COMPANY / PROJECT
ST185 CELICA GT-FOUR - LINK ECU CONVERSION

TITLE
CSB3 ENCLOSURE - LID

PART / DWG NO.	REV	MATERIAL
ST185-CSB3-102	**E**	PA12 (MJF)

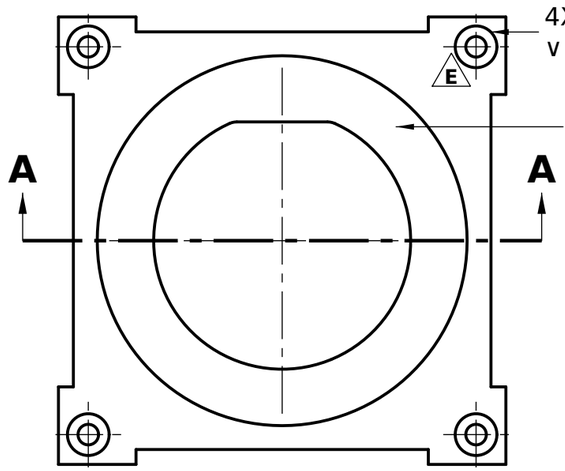
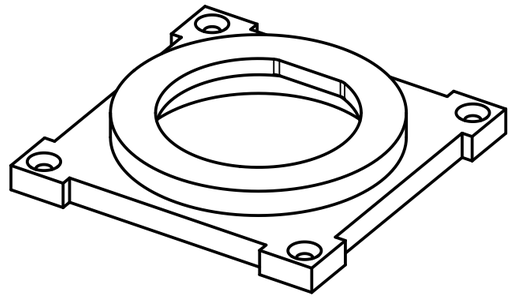
REVISIONS			
REV	DESCRIPTION	BY	DATE
A	Initial	DG	13/10/26
B	Audit v3: F09 D-hole corners R3 (#272)	DG	16/10/26
C	R132 lid loft D62 x 6 (#273); first drawing issued (#280)	DG	16/10/26
D	D43.08 x 0.2 round relief at the HD34 flange seat: the flat starts 0.2 up, so the round root of the HD34 pilot (TE model) clears	DG	19/10/26
E	D5 a1 corner ears: lid holes move to (±32.5, ±32.5), 3.45 through, 90 degree countersink to 7.0. PA12 MJF (Dan 2026-11-09)	DG	09/11/26
